**Re: Ash Street Water Transmission Pipeline
([PR#145-2025](#))
City of Dallas ([PWS ID#00248](#))
Conditional Approval**

Thank you for your submittal to the Oregon Health Authority's Drinking Water Services (DWS) of plan review information for the *Dallas Ash Street Water Transmission Pipeline Project* on behalf of the City of Dallas. On November 5, 2025, our office received a engineered plans and plan review fee payment in the amount of \$3,300.

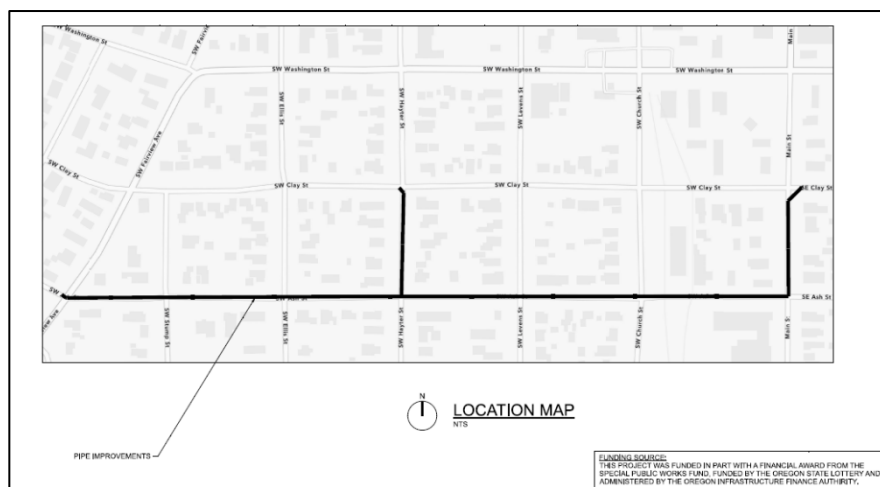
The project includes the installation of approximately 2500-LF of new 16" dia. Class 52 ductile iron pipe (DIP) along SW Ash Street, ~340-LF of 10" DIP along SW Hayter Street and ~340-LF of 16" DIP along Main Street as shown below.

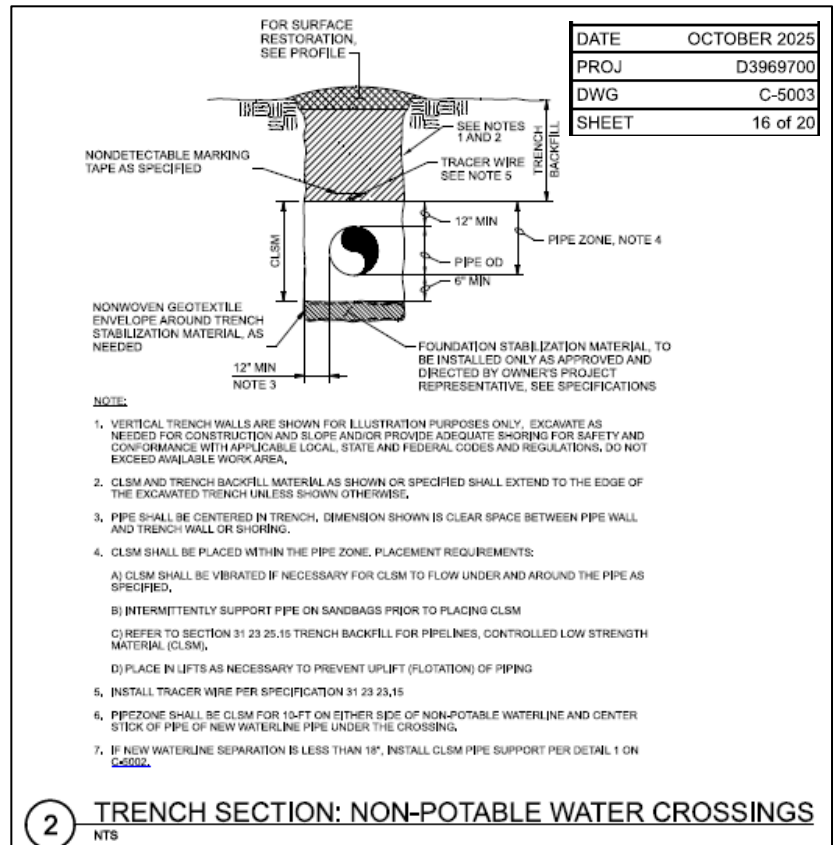
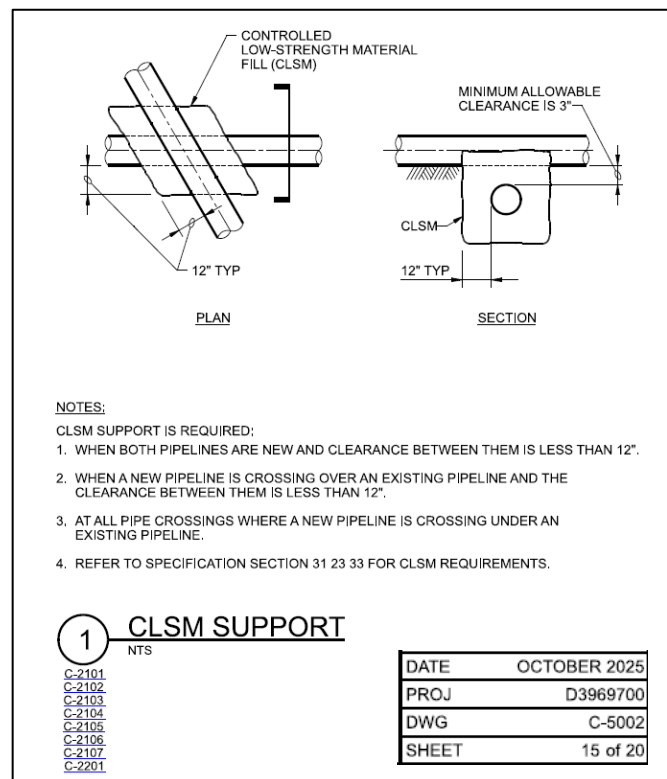
A construction standard waiver was requested for OAR 333-061-0050(9)(c)(C) regarding waterline - storm/sewer line crossings on November 5, 2025. This waiver request allows for encasing water main in controlled low strength material (CLSM) for a minimum of 10-ft on both sides of a non-potable pipeline crossing, without further excavation of the non-potable pipeline to assess pipe condition beyond the water main trench.

This waiver was approved on 11/19/25 and is available online at:
